SERVICE BULLETIN No. 300-3-94

Subject: Canopy Latches

Models affected: EA-300/S

Fig 1. Potential crack areas of the latches

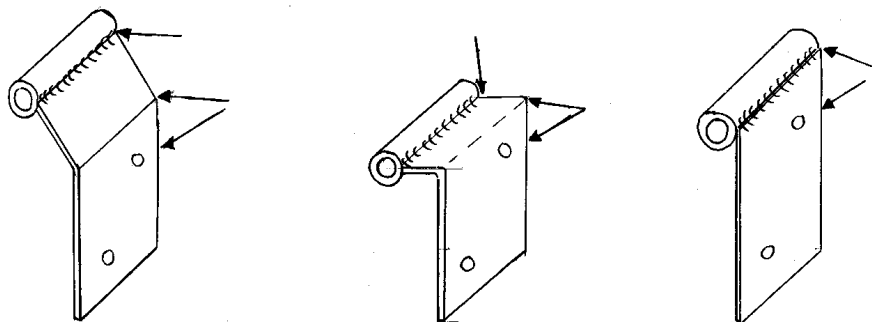
- Inspect all canopy latches which hold the lock and hinge sleeves for cracks at mounting bolt holes and at the adjustment bends of the latch as shown in figure 1. (So far only the front latches were reported to have failed. Cracks have not been reported from the rear latches.). Make sure the mounting bolt holes are round. Some latches unpermissibly have been modified with enlarged holes to adjust the fit a new canopy. New canopies need to be installed with new latches only.

- The latches (especially on the canopy side) commonly show cracks in the paint coating. Therefore the paint coating should be partially removed prior to structural inspection. Apply a corrosion preventive coating afterwards.

Fig. 2. Latch modification

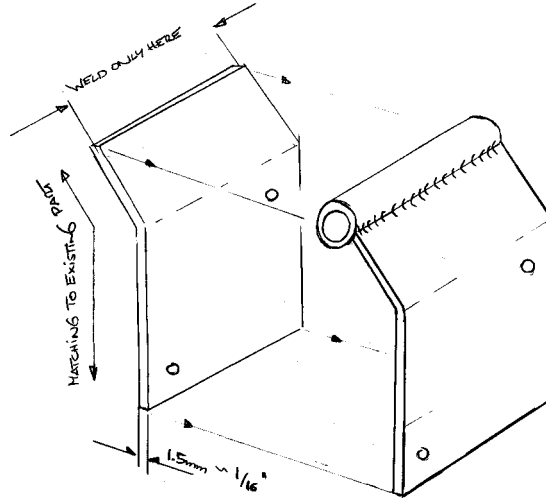
- In case cracks are found in the latches perform modification of the latches according to figure 2 or install new latches (P/N PC-23303.8P1 for both front latches and the rear right; PC-23303.8P2 for rear left).

- The latches are custom fit for every A/C. Hence new parts need to be trimmed for the specific application. When ordering new parts please exactly specify the dimensions of your latch (length, bend angle, and sleeve position). Reinforcements of old parts as shown in figure. 2 are to be custom fit as well.
- The modification and the new parts feature a doubled latch steel sheet to provide a redundant load path. Upon installation of the modified / new parts apply wax or penetrating oil to prevent corrosion between the two sheets.
- Make appropriate entry of compliance with this Service Bulletin in the aircraft logbook.

- For the modification use 1.7734.4 or 4130 steel, 1.5mm thick
- Weld reinforcing sheet to sleeve only
- Apply wax or penetrating oil between sheets
